FILE P. I. No. 110630-, Jackson County
NH-IM-85-2(167)
I-85 Widening and Improvements
from North of SR 53 to North of SR 11

SUBJECT APPROVED REVISED PROJECT CONCEPT REPORT

REVISED PROJECT CONCEPT REPORT

I-85 Widening and Improvements from North of SR 53 to North of SR 11
Project Number: NH-IM-85-2 (167)
County: Jackson
P. I. Number: 110630

STATE OF GEORGIA
DEPARTMENT OF TRANSPORTATION
OFFICE: CONSULTANT DESIGN
TYPICAL SECTIONS

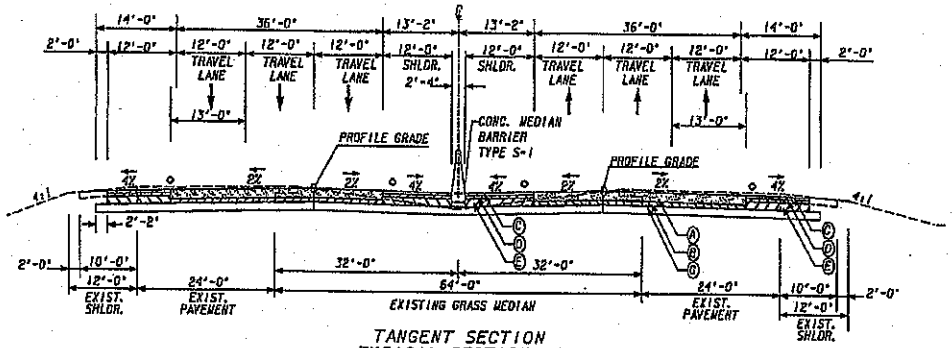
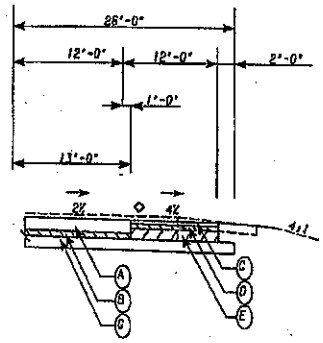
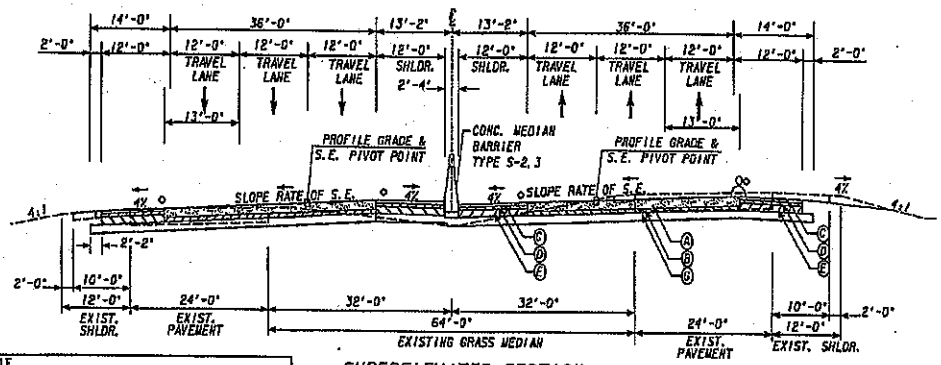
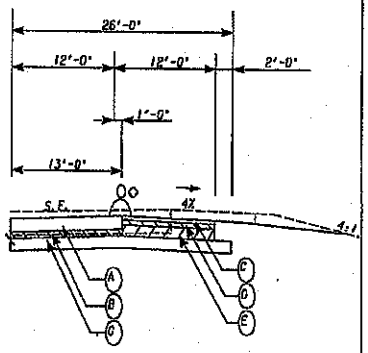
The approved typical sections will be changed to match the adjacent project to the south. From mile log 129.4 to 134.0 and 135.1-137.3, the profile grade will be changed from 14' left and right of centerline to 25.17'. From mile log 134.0-135.1, *the profile grade will be 79.17' instead of 88'. For the whole project length, the inside paved shoulder will be 12' wide instead of 12.75' and 10'. The outside travel lane will be paved for 13' instead of 12' and striped as a 12' lane. The extra foot is included in the width of the outside paved shoulder. The outside shoulder consists of a 12' paved shoulder and 2' unpaved where as the approved concept showed a 16' paved shoulder (See attachment for details.)*
  - Structure
